AIRWORTHINESS DIRECTIVE

SZD-9 BOCIAN 1E SAILPLANES

Replacement of elevator horn alloy rivets with steel rivets.

BULLETIN No BK-023/82 "BOCIAN-1E"

Fig.1.

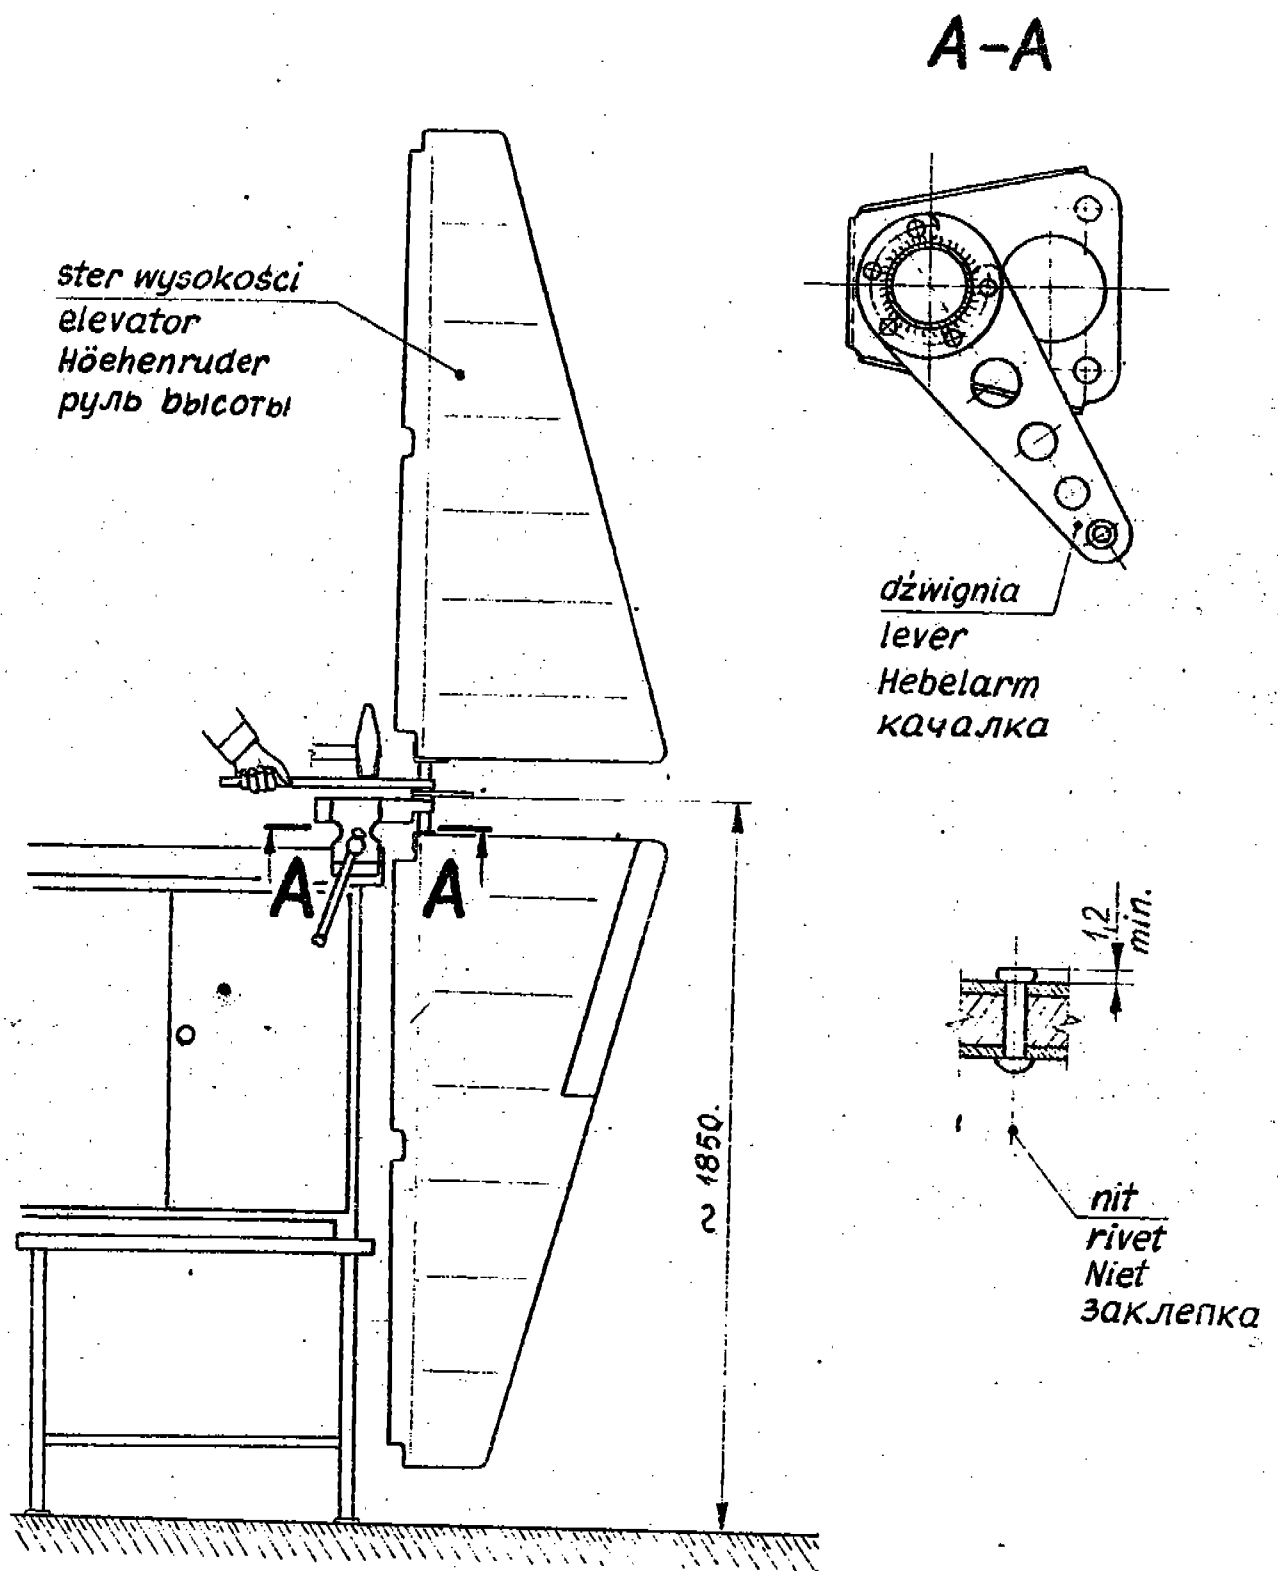
To this Bulletin the sketch Fig. 1 describing the above mentioned lever and the way of riveting it is enclosed.

The change defined in this Bulletin depends on the replacement of duraluminium rivets by the steel ones of the same dimension in the connection mentioned above.

- 5.1. Disassemble the horizontal tailplane out of the glider
- 5.2. Disassemble the elevator out of the stabilizer.
- 5.3. Cut off by means of chipper the heads of 3 rivets /each second in the rivet-row/ connecting the lever with torque tube shells /pay attention to avoid the damage of torque tube!/.
Remove the rivets and replace the new steel ones /steel 45/.- 5.4. Fasten the rivets on crossed sequence /beat the rivets by intermediation of metal strip/.
Minimum height of formed rivet head should range 1,2 mm, Pay attention that the rivet correctly plugs the hole diameter. For this reason a hammer of about 1 kg mass and the support of about 2 kg mass are necessary.
- 5.5. With the rest of rivets proceed similary to instructions of items 5.3. and 5.4.
- 5.6. Formed rivet heads should be protected with the pad for metal.
- 5.7. Assemble the elevator, check the operation.

At or before the next Form 2 inspection replace the 6 alloy rivets with steel 3 mm dia. rivets, supplied by the manufacturer. Alternatively open the holes to 1/8" dia. and fit AN 435-M4 Monel rivets, MS206134C (or equivalent) length as required.
